### ADDENDUM NO. 3

Date Issued: October 11, 2024

<b>PROJECT NUMBER:</b>	10-19202-00
<b>PROJECT NAME:</b>	Jennings Community Center
<b>CLIENT NAME:</b>	City of Jennings
<b>PREPARED BY:</b>	KAI Design 2060 Craigshire Dr, St. Louis, MO 63146

SHEET NO.  
**E101**  
 Copyright © 2021 KAI Design, LLC  
 All Rights Reserved

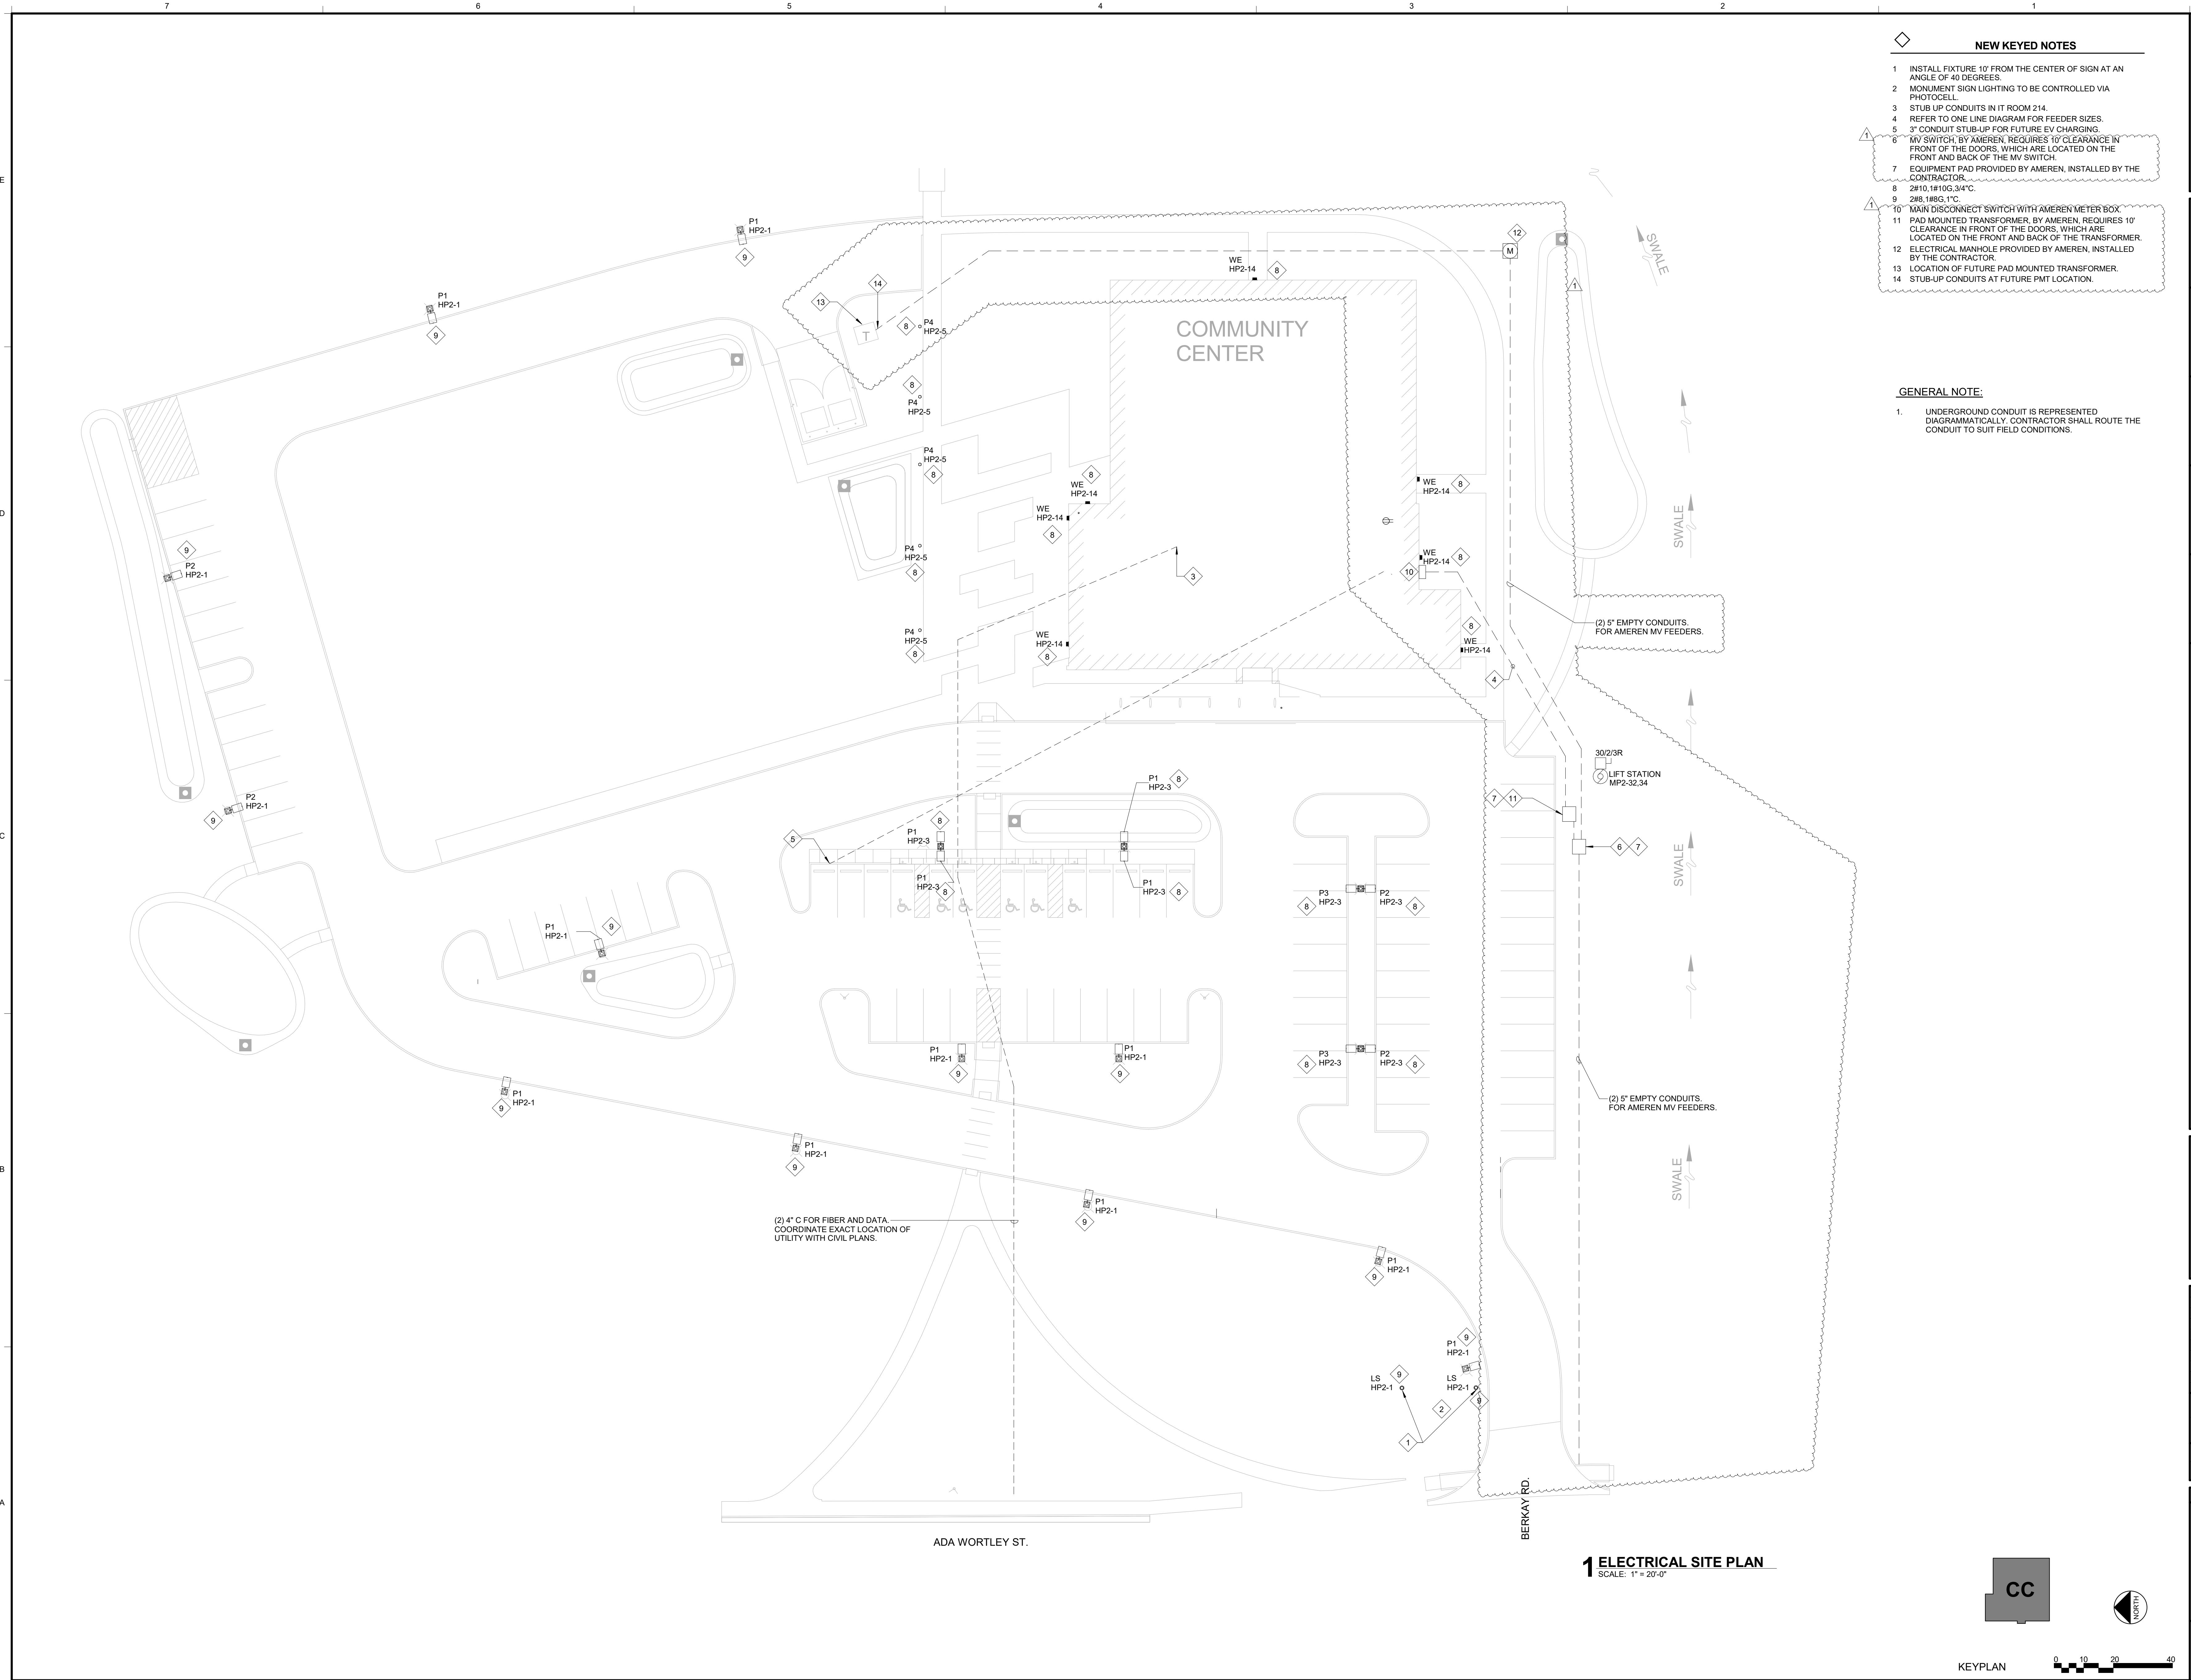
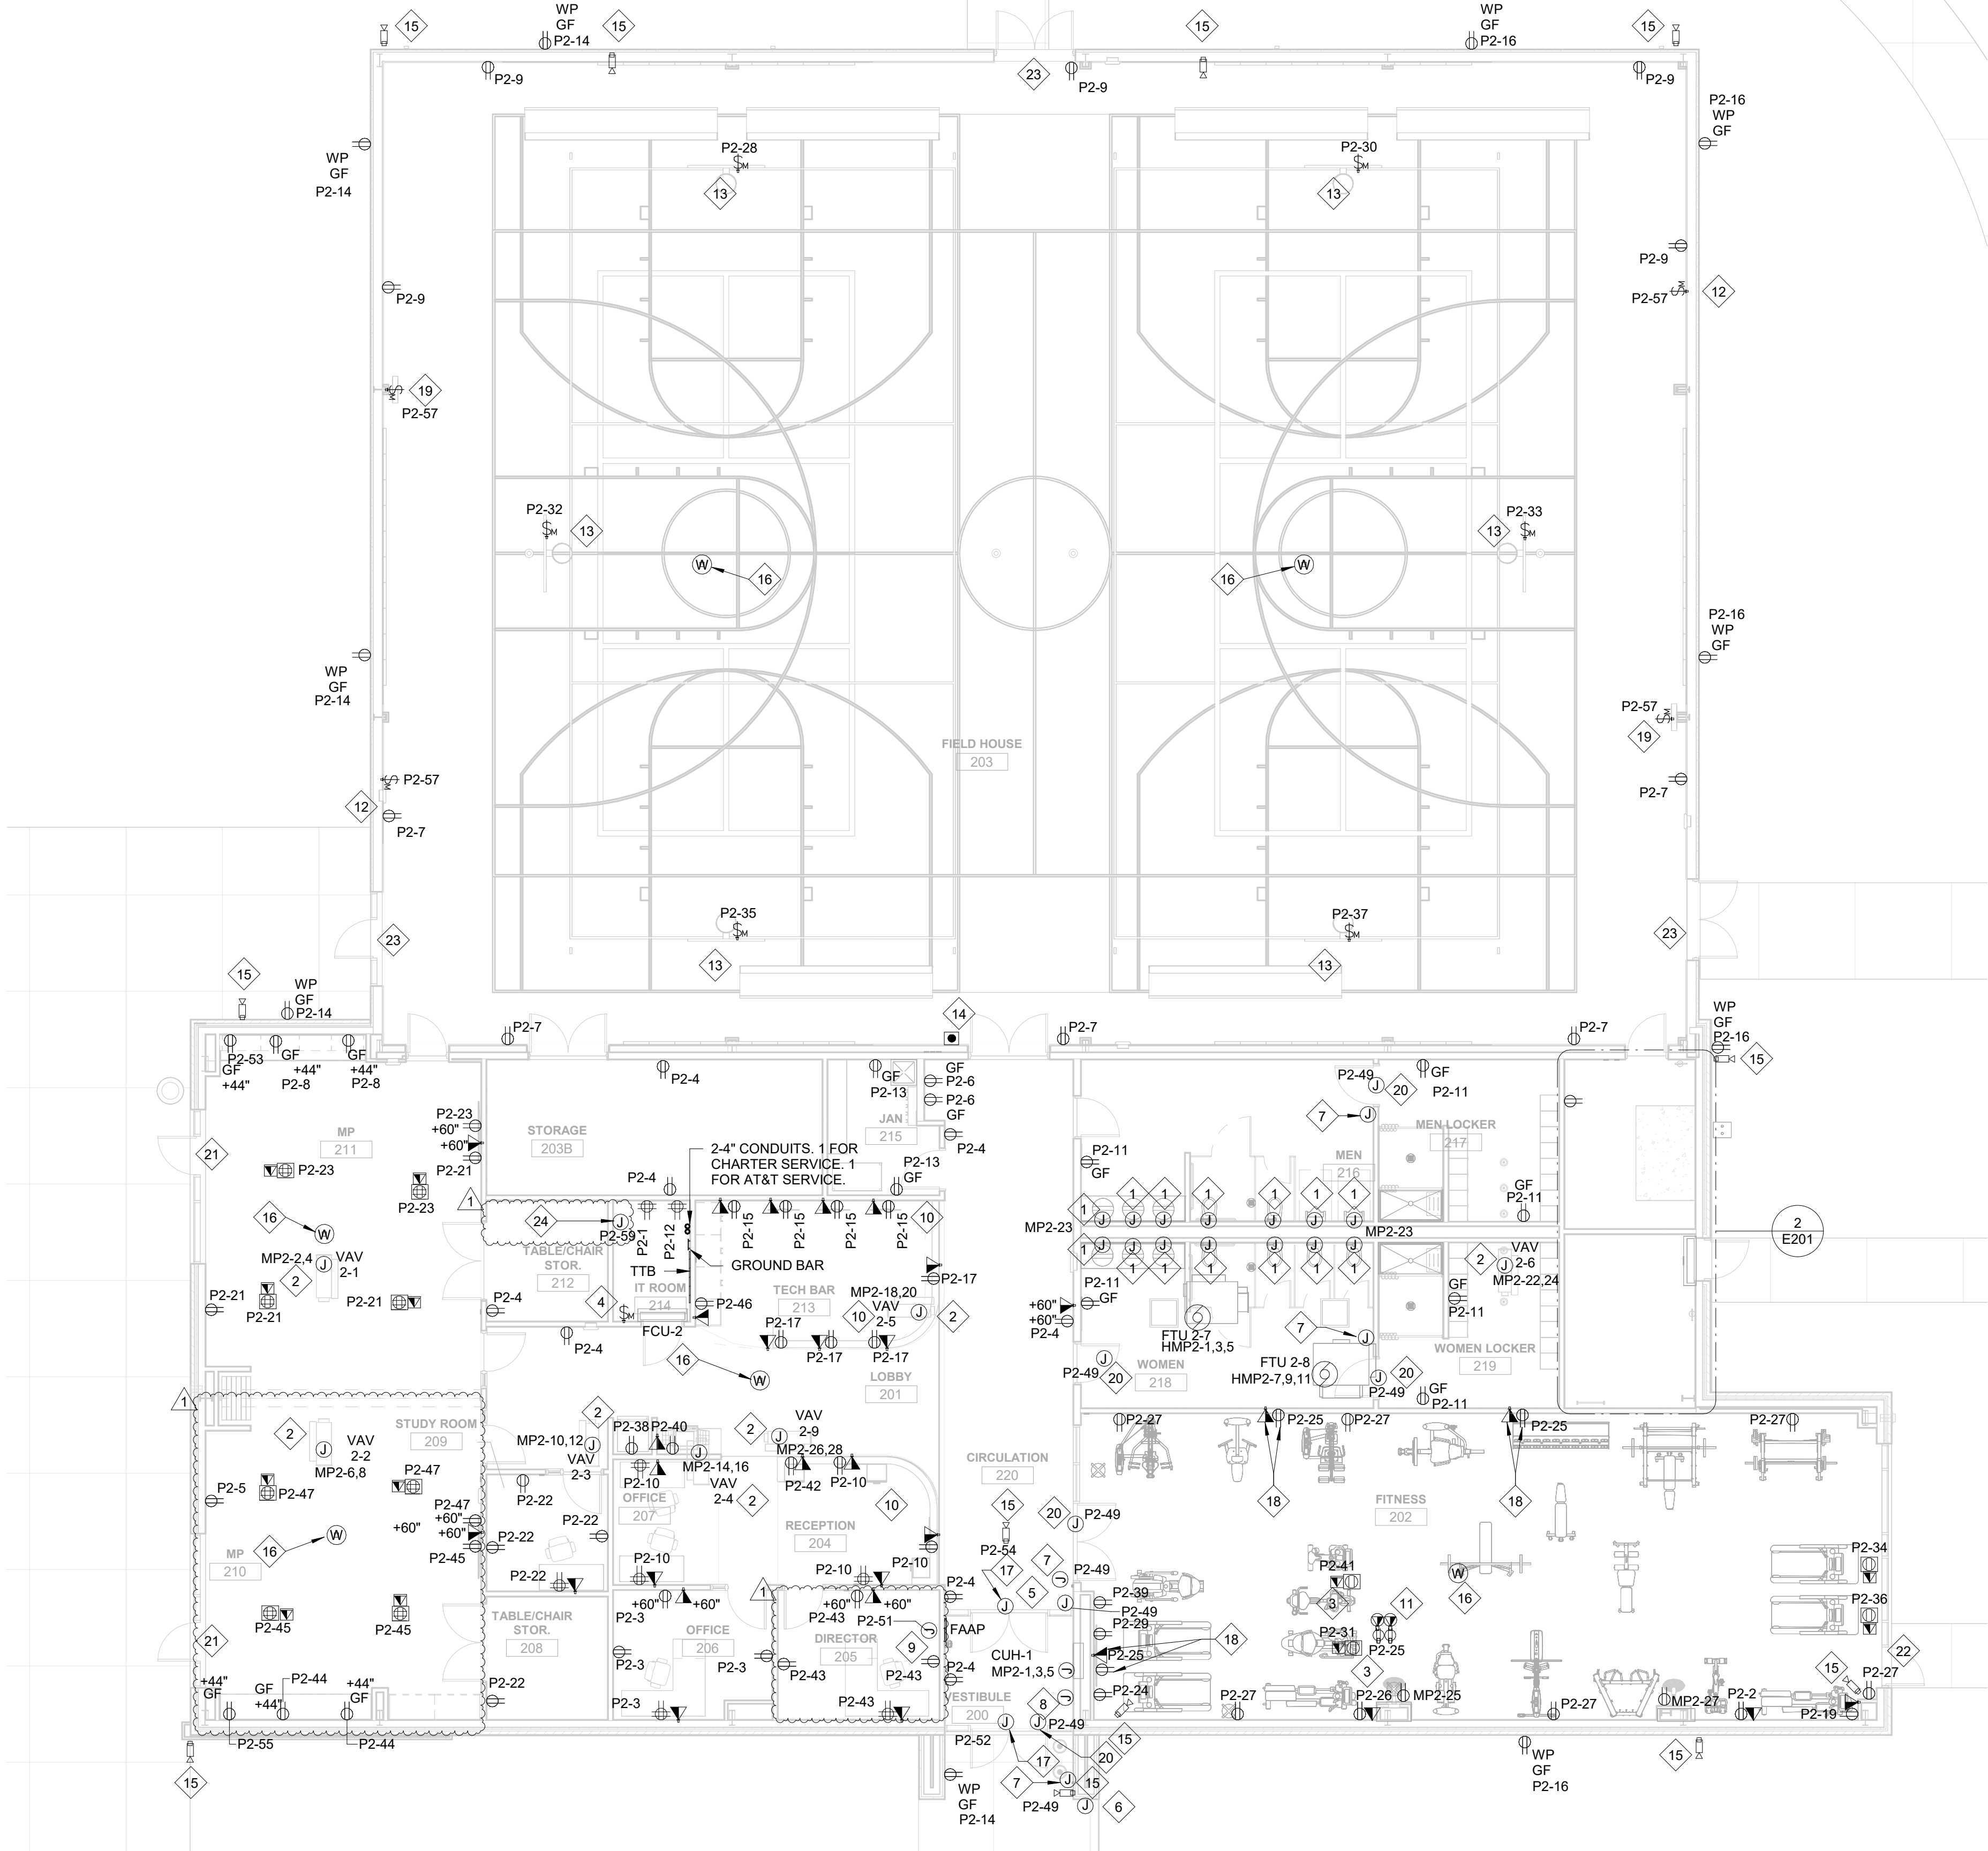
SHEET #	DESCRIPTION OF CHANGES
E001	Deleted symbols for receptacles on emergency power from the Legend.
E101	Revised design for utility power equipment and feeders per AMEREN's requirements.
E201	Revised all receptacles indicated as emergency to standard symbols. Added 20A, 120V circuit for access control system panel in IT room 214. Added one general purpose receptacle and fed receptacles from circuit P2-19 in Mechanical Room 222.
E501	Revised Detail 9 to include cables for data outlets in scope. Replaced CAT 5 cable with CAT 6 cable in Details 2 and 6.
E604	Added 20A, 120V circuit for access control system panel in panel P2.
E701	Added exterior disconnect switch and meter box per AMEREN's requirements.
